MINUTES MHCC REGULATORY SUBCOMMITTEE MEETING

November 28, 2016

Action Item 8: Foundation Systems Requirements in Freezing Climates

Figure 2. Installation detail for Example#1 (FFF using crushed stone pad on subgrade)

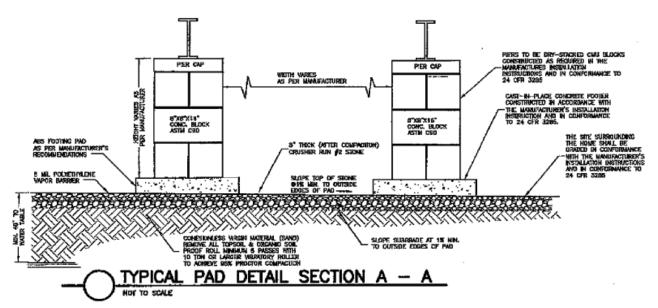
This design represents a reasonable application of the FFF technical requirements in accordance with Section 4.2 of the ASCE 32 standard. For example, it appropriately defines non-frost-susceptible material and requires it to be well-drained and to extend below the required frost depth. However, it places the burden on the local authorities for determining frost-susceptibility for each site application of the design, while at the same time requiring engineering verification (see "DESIGN NOTES" below). The reverse process is more appropriate (i.e., the engineer determines and the authority verifies). This may cause some unintended confusion as to roles and responsibilities which may be entirely missed by installers and those responsible for enforcement. Local authorities have an inspection and verification role, not a construction management or design decision-making role. To do otherwise creates a conflict of interest due to a lack of appropriate separation of roles and responsibilities.

This FFF design also includes a detail (Figure 2) which requires the subgrade to be cohesion less (sand) extending to a minimum depth of 48 inches and compacted with a 10 ton or larger vibratory roller. The water table is required to be at least 48 inches below finish grade together with surface grading required to meet the HUD code. Thus, the detail seems reasonably consistent with the technical intent of the design notes, despite confusion regarding important installation process considerations related to roles and responsibilities as mentioned above. However, the indicated "cohesion less (sand)" subgrade material could be moderately frost susceptible if it is a very fine sand (e.g., approaching silt-size particles). Thus, the Design Notes and plan detail should be clarified that the "6% of mass passing #200 sieve" also applies to the vaguely described cohesion-less sand material in the installation detail.

provide adequate protection against frost action. Furthermore, the 8" layer is located above what is intended to be a well-drained, non-frost-susceptible subgrade. In such a case, this sub-drainage will keep the 8" layer reasonably dry, particularly where located below the manufactured housing unit and protected from rainfall and runoff. Thus, the critical component of this design is assuring that the subgrade is indeed non-frost-susceptible and well-drained as called out on the plans consistent with the ASCE 32 standard.

Figure 3. FFF installation detail for Example #2 (FFF with piers directly on soil) based on SBRA/Hayman (2010) report.

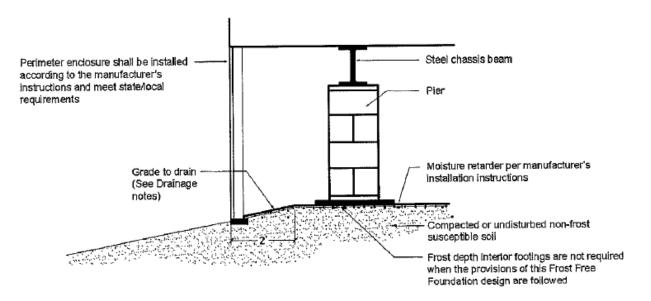
This design has a distinct difference from Example #1 and the ASCE 32 provisions: it relies exclusively on ensuring that "the soil beneath the manufactured home stays dry thereby preventing frost heave." The report by SBRA/Hayman (2010) mistakenly claims that "Soil type is not relevant using the Frost Free Foundation design. Soil tests are not necessary." For reasons discussed below, it is the opinion of this author, having served on the ASCE 32 committee and its task group on development of the non-frost-susceptible soil criteria, that these statements are not representative of the intent of the ASCE 32 standard or equivalent alternative procedures for ensuring the intent is met. (Refer to the earlier discussion on the meaning of key terms and clauses in the ASCE 32 standard.)

For example, the installation detail based on the SBRA/Hayman (2010) report reveals the following (see Figure 3):

- It leaves discretion for the means and methods of establishing the water table depth to the local authority. This is a design decision going beyond the role of regulatory authorities, creating a conflict of interest in their role and the practice of design and installation. The plans should specify a means of determining water table depth following accepted engineering practice and require that it be at or well below the frost depth if merely a "point-in-time" investigation is done by others than a geotechnical engineer or experienced professional.
- 2. It provides no means of determining or verifying the use of non-frost susceptible soil as required in the detail (but which is indicated as being unimportant in SBRA/Hayman (2010)). Such a practice is important and such inconsistencies unnecessarily confuse the issue. Specifications

Figure 4. Installation detail for Example #3 ("Floating Slab" FFF)

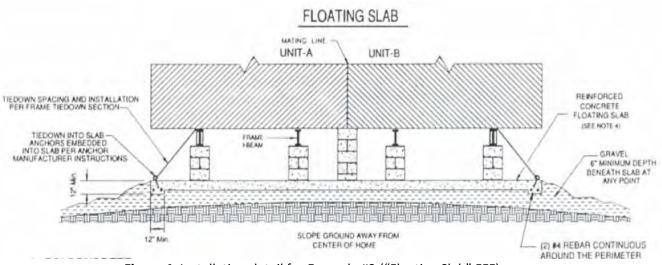
- 1. Note #1 requires use on sites with "well drained soil with an average moisture content less than 25% to frost depth". The means of determining the average moisture content to frost depth is not specified. Is this an average at a given point in time or an average including seasonal variation? Is the moisture content volumetric or by mass? Does 25% average moisture content provide adequate frost protection for all frost-susceptible soil types? For example, soil may approach saturation at a volumetric moisture content of 25% or be saturated at a gravimetric moisture content of 20%. Furthermore, if soil moisture content is measured to a frost depth of say 4 feet, the top two feet may be relatively dry, but the bottom two feet wet; yet the average moisture content may meet the stated criteria (even though the overall moisture condition of the soil would promote frost heave in a frost susceptible soil a risky soil condition which is not prohibited by this design). Clearly, the specification is incomplete and vague. Yet, this criteria is presented as the main "pass/fail" criteria for acceptance of a site for use of the "floating slab" FFF design.

Figure 5. FFF installation detail for Example #4 (Monolithic Slab FFF)

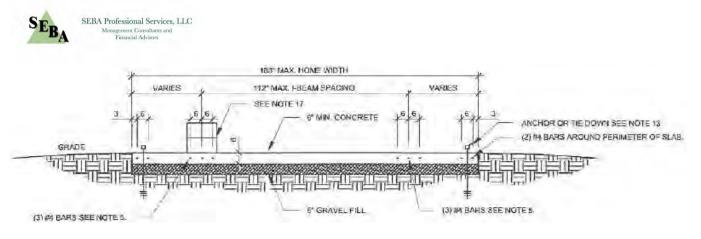
Second, general note #8 does seem to clarify that a gravel base must be below the frost line. Yet, the gravel base is not specified as to the amount of fines that can be tolerated. Is the intention to use clean (washed) gravel or bank run? Furthermore, the detail implies a shallow depth is intended (or may be interpreted) since the frost-depth is not shown to coincide with the depth of the gravel fill. Without careful installation and enforcement, the design intention may be overlooked or not be properly executed in the field.

Finally, note #9 indicates that drainage must be provided under the slab, but the drainage design is not defined or indicated on the detail other than to say that water is to be drained "to the perimeter of the slab". This may actually cause water to be concentrated at the edges of the slab where differential frost heave would be promoted. It also does not clarify where the drainage system is to be placed (e.g., at the bottom of the gravel layer) and that drainage water should be discharged to daylight well away from the perimeter of the slab foundation. The building code is referenced for detailed requirements, but building code foundation drainage requirements generally are not intended to address this application (e.g., drainage of fills and subgrades to prevent frost heave). The design should show a drainage plan for cases where the sub-grade is not well-drained (e.g. water table not below the frost depth or a soil layer at depth with a low infiltration rate).
